**Date:** November 29, 2021  
**To:** Craig Dumart, Senior Planner  
**From:** Victoria Grohn, Senior Planner (Heritage)  
**cc:**  
**Subject:** Resubmission 1  
Official Plan Amendment OPA21/001/F/DE  
Zoning By-law Amendment ZBA21/002/F/DE  
30 Francis South  
Heritage Planning Comments

**Re: Proposed Official Plan Amendment OPA 21/001 and  
Zoning By-law Amendment ZBA 21/002  
30 Francis Street  
GSP Group Inc. on behalf of IN8 Developments  
CITY OF KITCHENER**

**Re: Noise Study  
OPA 21/001/F/DE and ZBA 21/002/F/DE  
30 Francis Street S. follow up to Regional Comments  
IN8 Developments  
CITY OF KITCHENER**

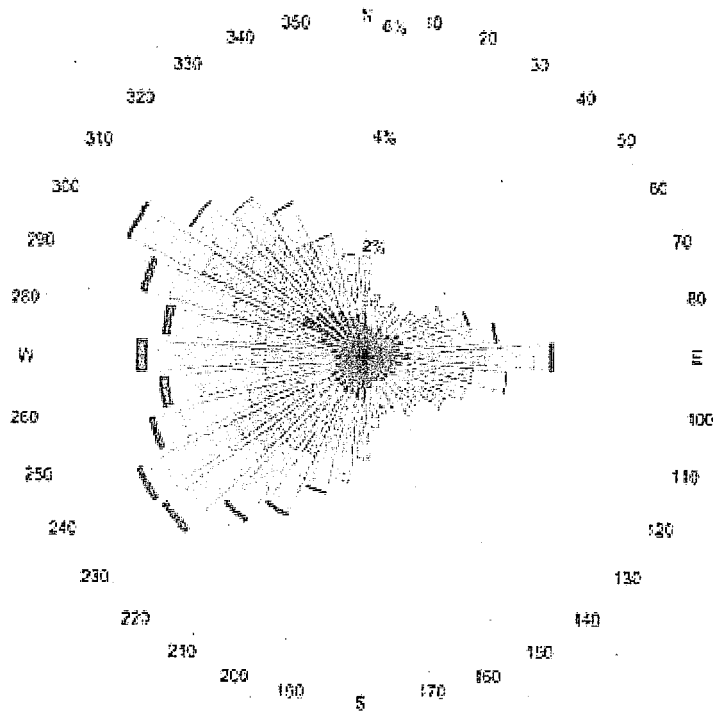
*The predominant winds in Kitchener in the winter, when you will typically see uncomfortable wind conditions, are from the westerly directions as per the wind rose below. There is a small easterly component but it is not significant. Depending on the design of the future building across the street wind conditions will be changed along Francis Street South. Without knowing the potential massing of the future development (footprint, height, building setbacks etc. ) it is not possible to comment on how these conditions may change. Similar to how we saw improvements with the implementation of wind mitigation measures on our site, if conditions are not favourable*

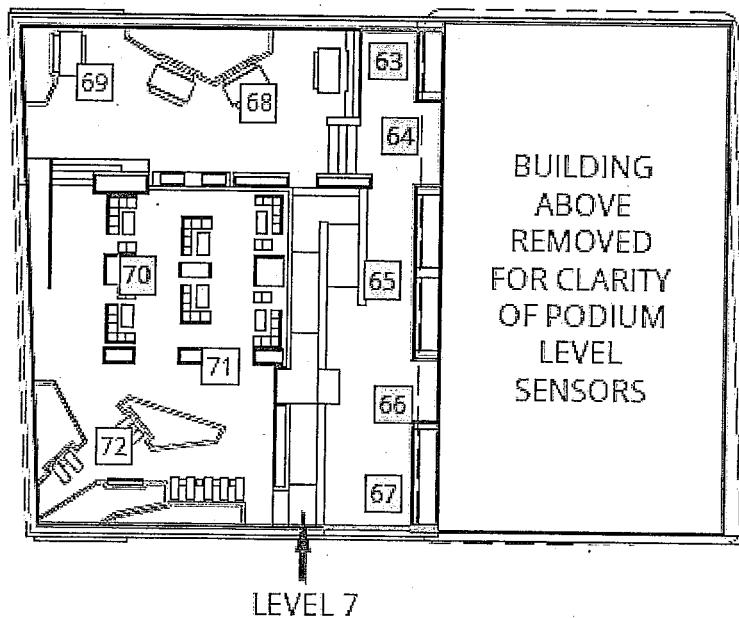
*The Wind Study should be updated to show mitigating measures for the wind impact along Charles and Francis Streets as well as Halls Lane.*

*Recessed building massing, canopy overhangs and wind screens have been utilized to address any uncomfortable winds identified around entrances, corners and down-draft locations at-grade. Furniture, planting and wind screens have been utilized to address any uncomfortable winds founds at the Level 7 rooftop terrace.*

The updated wind study (dated October 1, 2021) notes acceptable levels at grade on the Francis St Charles St and Halls lane. The Level 7 Upper Terrace modeling is to be revised to note the current proposed landscape/rooftop amenity plan. The screen capture below is from the current revised wind analysis

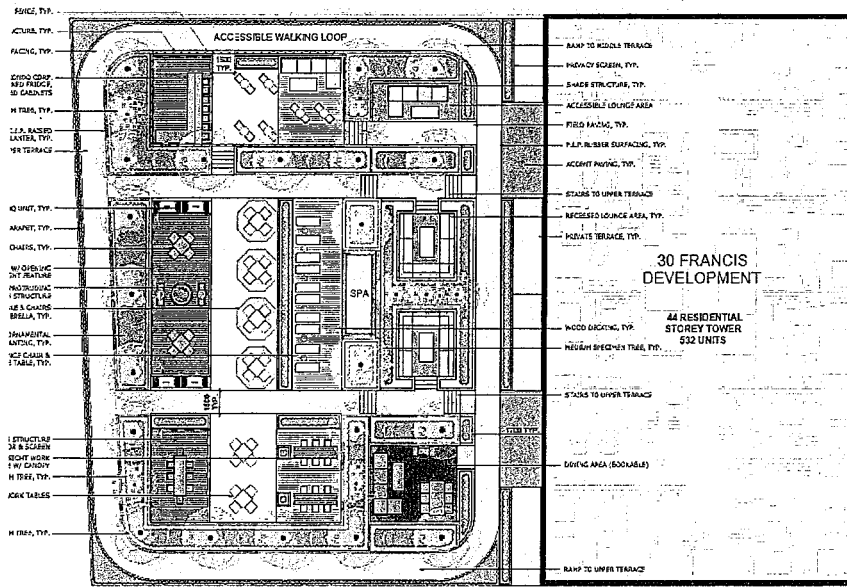
The most current proposed level 7 landscape plan (see screen capture below) provided by the applicant does not match the one modeled in the wind study. The applicant is advised that all outdoor amenity areas are to have sitting windspeeds in summer months and standing wind speed during winter months.

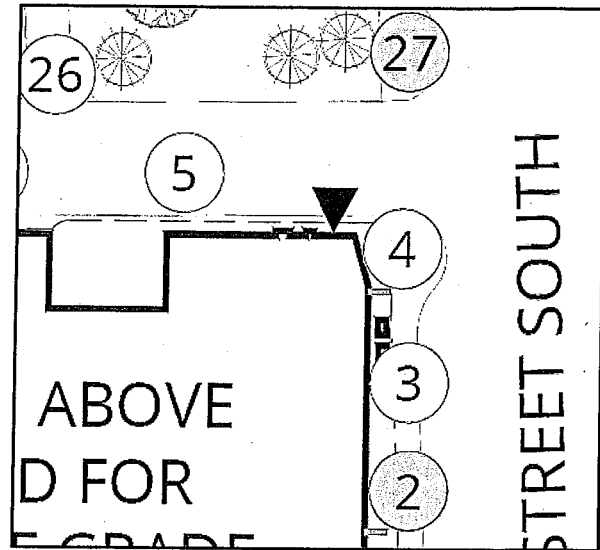
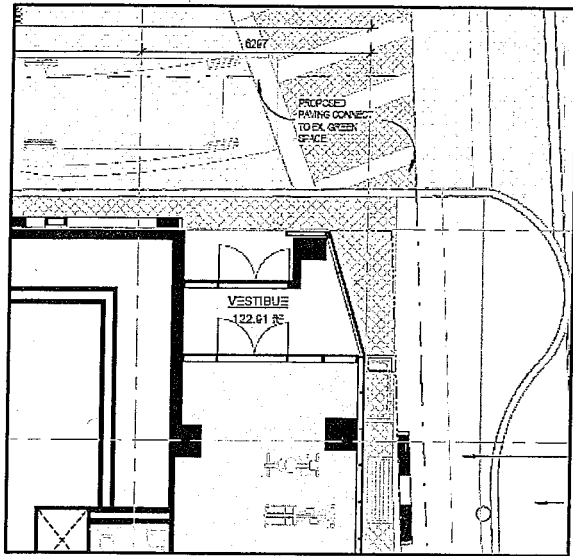
*Primary entries along Francis St. S and Charles St. are to be designed to have wind speeds that allow sitting in summer months and standing in winter months.*

The revised wind study appears to have achieved the above required criteria save and accept in one location (sensor 4) see image to the right below. The Image to the left notes the proposed entry is recessed confirmation is to be provided that wind speeds in the new entry would allow for sitting and standing as noted in the previous staff comments.
